# A D D E N D U M 1

This Addendum consists of the following information:

DISTRICT-WIDE CAPITAL IMPROVEMENTS  
**HIGH SCHOOL & MIDDLE SCHOOL HVAC UPGRADES**  
 CHAPPAQUA CENTRAL SCHOOL DISTRICT  
 66 Roaring Brook Road  
 Chappaqua, NY 10514

Sheet Title  
**HORACE GREELEY  
BUILDING "H"  
POWER PLAN**

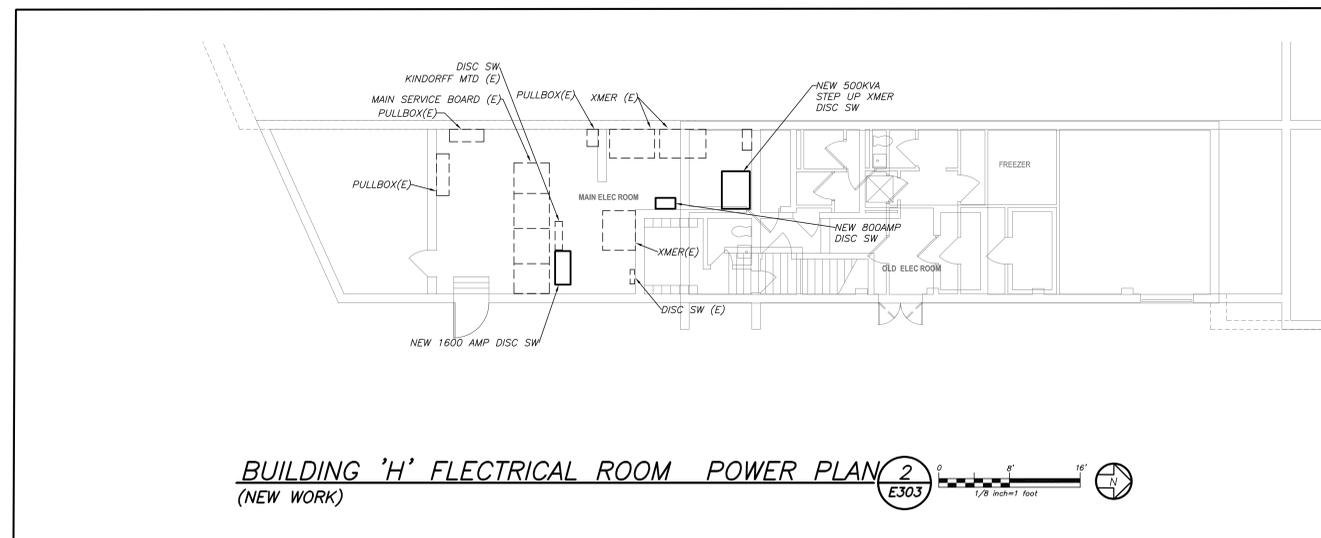
- 6. DRAWING E301-HG HORACE GREELEY BUILDING “A” POWER PLAN
  - a) Refer to revised drawing included in this addendum.
- 7. DRAWING E303-HG HORACE GREELEY BUILDING “H” POWER PLAN
  - a) ADD power for condensate pumps.
- 8. DRAWING E501-HG HORACE GREELEY POWER RISER
  - a) Refer to revised drawing included in this addendum.
- 9. DRAWING E601-HG HORACE GREELEY SCHEDULE
  - a) Refer to revised drawing included in this addendum.

13. **Question:** *Please refer to H204-HG please confirm electrician is to furnish power wiring to various condensate pumps as required for routing condensate through existing complex architectural ceiling assemblies and existing ductwork.*

**Response:** Condensate pump is integral to the FC unit for ceiling units. Separate power required for wall mounted by EC included within this addendum.

- 1 PROVIDE GF RECEPTACLES FOR NEW CONDENSATE PUMPS. COORDINATE EXACT LOCATION AND MOUNTING HEIGHT WITH MECHANICAL CONTRACTOR BEFORE THE START OF ANY WORK.
